# Access Compliance Report

## Public Rights-of-Way

### (Curb Ramps)

Intersection ID: 12896	Main Street: E_6TH_ST	Cross Street: N_MCDOWELL_ST	Location: N
ADA ID: C9E34B9A55F4	Ramp Type: BlendTrans1	Initial Pass/Fail: Fail	Overall Compliance: No
Severity Score: 12.5			
Codes/Mitigation Info/Possible Solution		Field Measurements/Component Compliance

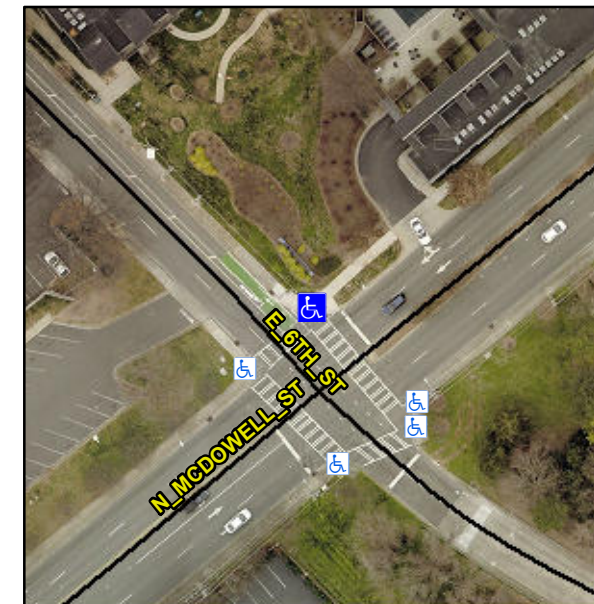
**Not Found, R304.5.3**

Compliance	Description	Data	Compliance	Description	Data
N/A	Ramp Length (in)	80.0	Yes	BlendTrans Slope (%)	2.4
Yes	Ramp Width (in)	130.0	No	BlendTrans XSlope (%)	5.6
N/A	Flare Type LT	N/A	N/A	Flare Type RT	N/A
N/A	Flare Slope LT (%)	N/A	N/A	Flare Slope RT (%)	N/A
N/A	Flare Traversable LT?	N/A	N/A	Flare Traversable RT?	N/A
N/A	Landing Length (in)	N/A	N/A	DWS Provided?	N/A
N/A	Landing Width (in)	N/A	N/A	DWS Contrast?	N/A
N/A	Landing Slope (%)	N/A	N/A	DWS Length (in)	N/A
N/A	Landing X Slope (%)	N/A	N/A	DWS Full Width?	N/A
N/A	Landing Curb? (Y/N)	N/A	N/A	DWS Offset (in)	N/A
N/A	Shared Landing?	N/A			
N/A	Gutter Ponding?	N/A	N/A	Gutter Slope (%)	N/A
N/A	Gutter Lip Ht (in)	N/A	N/A	Gutter X Slope (%)	N/A
N/A	Painted X Walk1?	Yes	N/A	Painted X Walk2?	Yes
	X Walk 1 Direction	To SW		X Walk 2 Direction	To SE
	X Walk 1 Width (in)	91.0		X Walk 2 Width (in)	110.0
	X Walk 1 Slope (%)	0.5		X Walk 2 Slope (%)	3.5
	X Walk 1 X Slope (%)	5.2		X Walk 2 X Slope (%)	2.1

N/A	Ramp inside XWalk1?	Yes	N/A	Ramp inside XWalk2?	Yes
	Road Slope (%)	4.0		Clear Space?	N/A
	Road X Slope (%)	2.2	N/A	Clear Space to XWalk (in)	N/A
N/A	Any Obstructions?	N/A	N/A	Storm Grate/Utility Hazard?	N/A
	Obstruction Type			Storm Grate/Utility Type	
		N/A			N/A
		Yes		Surface Condition? (G/P)	Good
		No		Curb Slope (%)	12.8

**Remove & Replace Curb Ramp With Two New Directional Ramps or Equivalent.**
